FINAL DRAINAGE PLAN

THE RIDGE AT LORSON RANCH

JANUARY, 2022

Core Engineering Group, LLC
15004 1ST Avenue South
Burnsville, MN 55306
(719) 570-1100

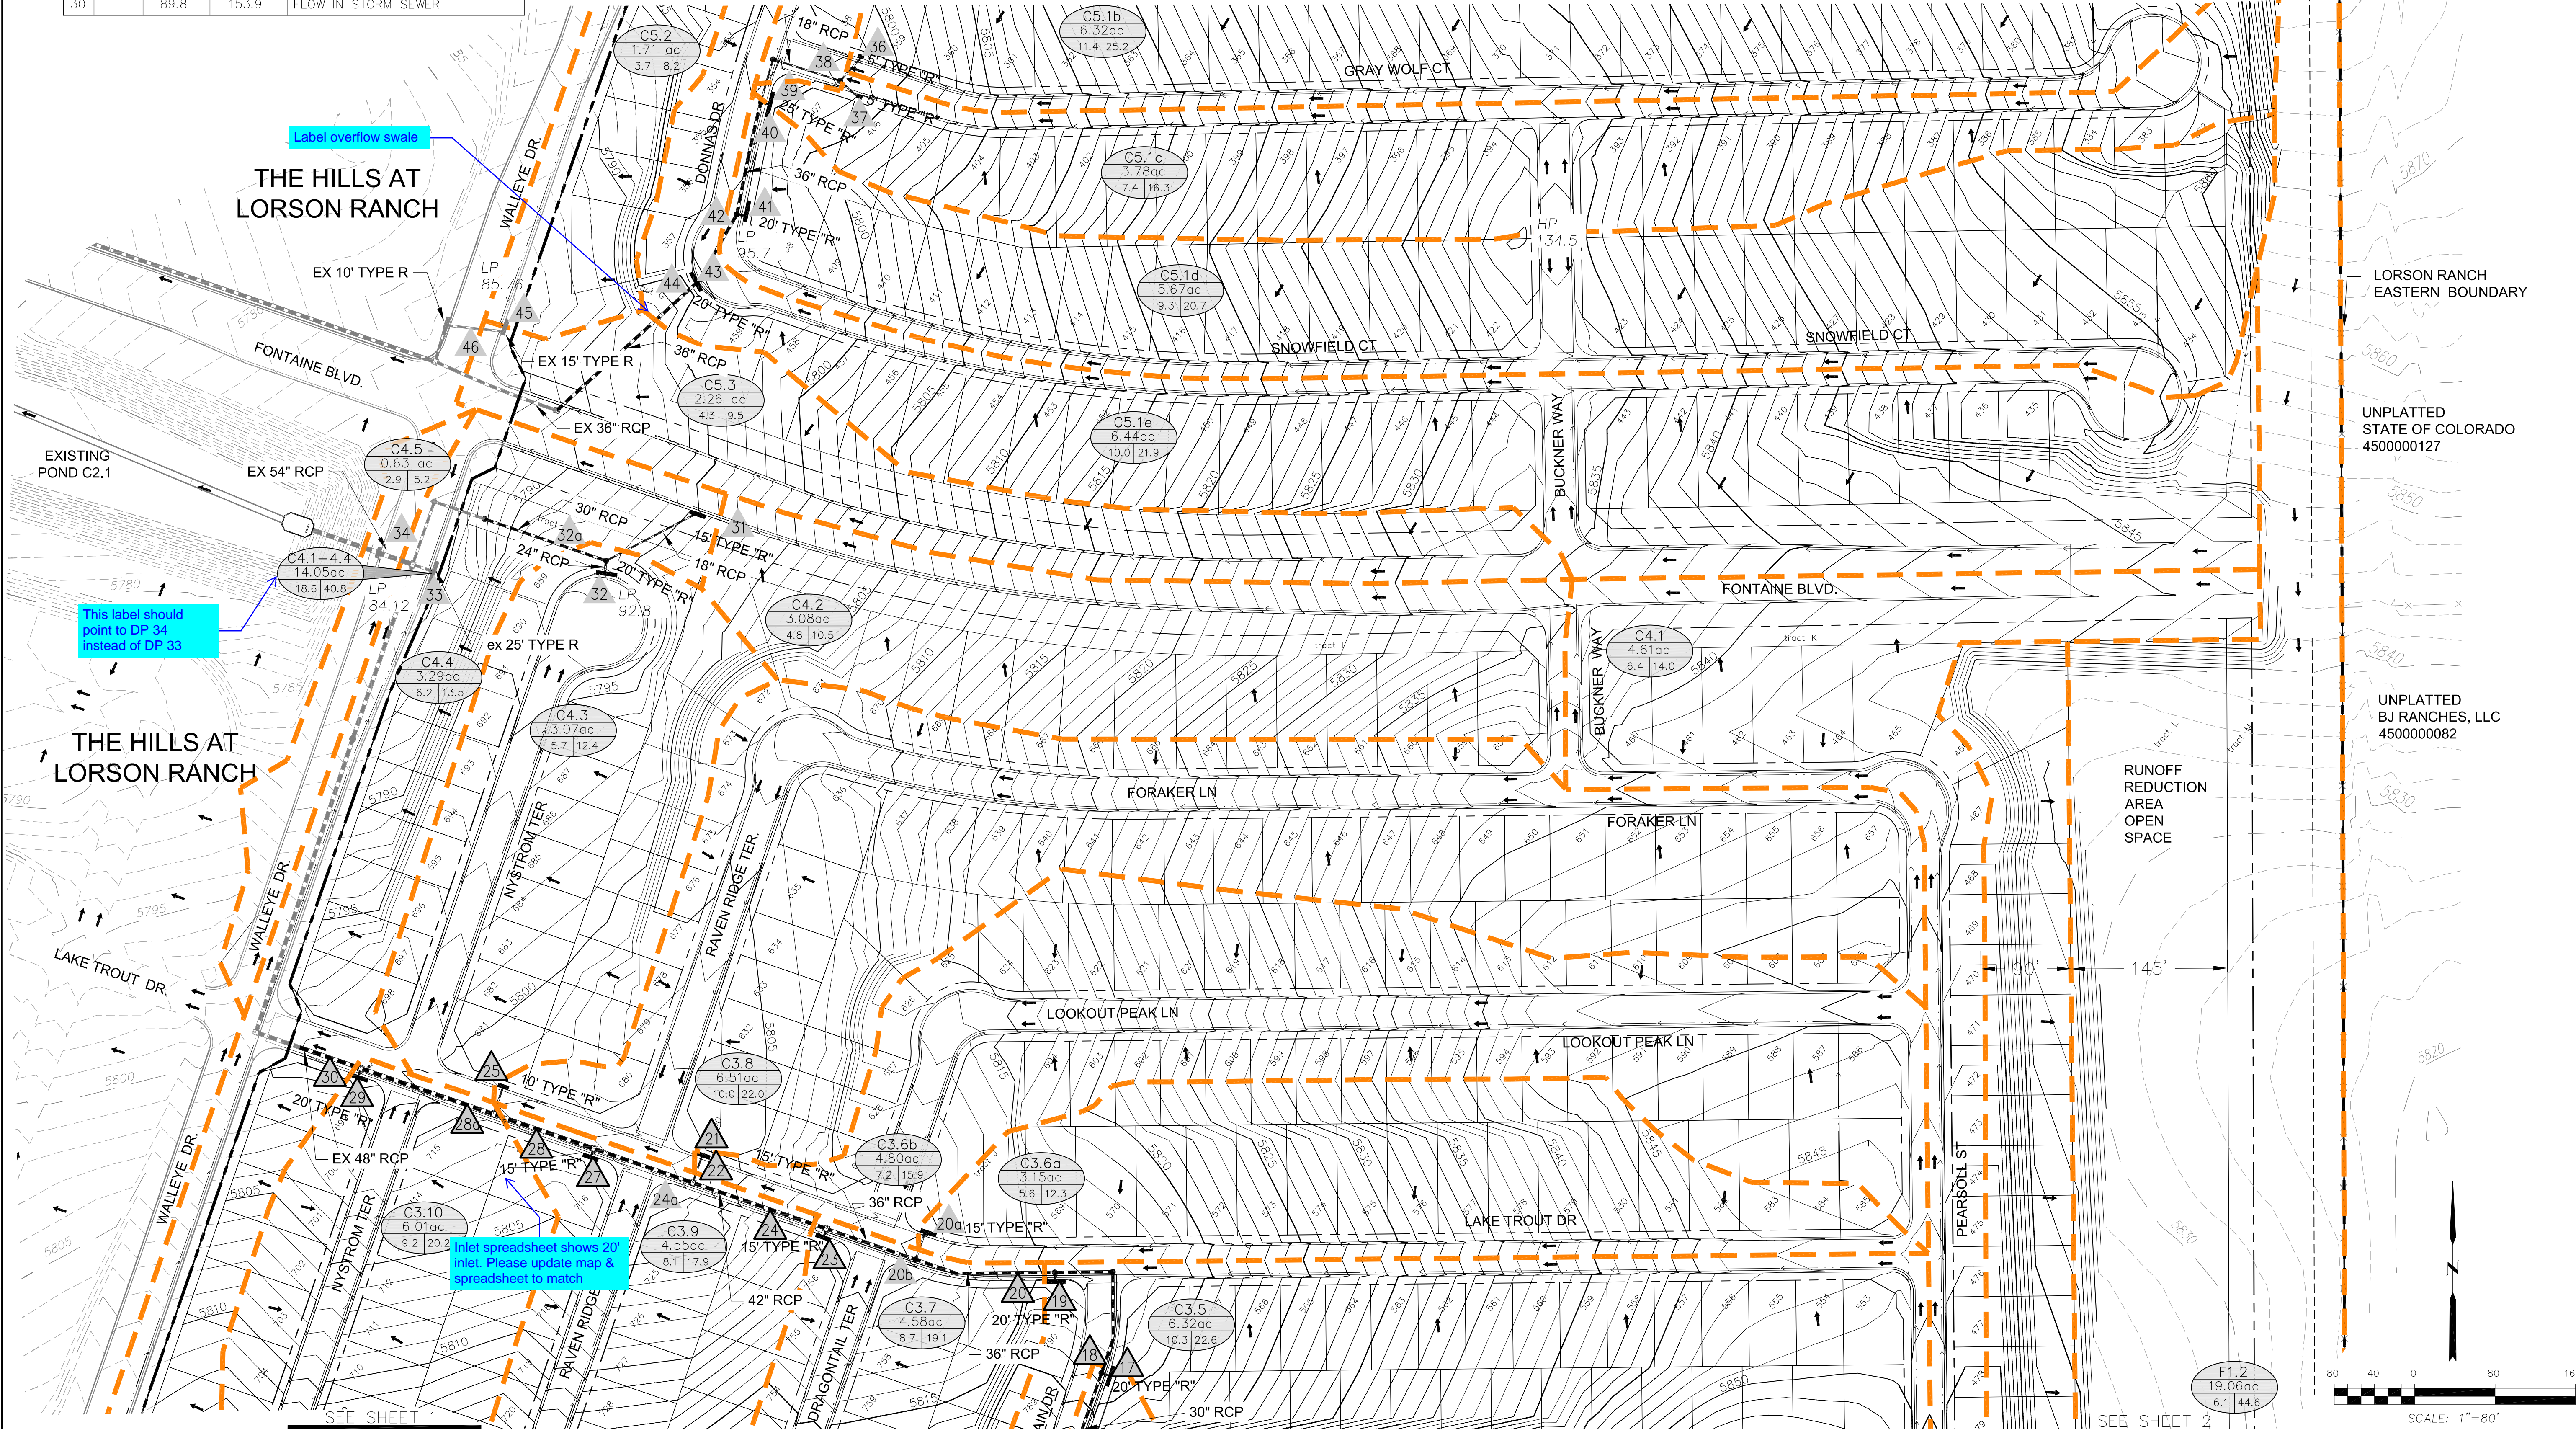
Label overflow swale
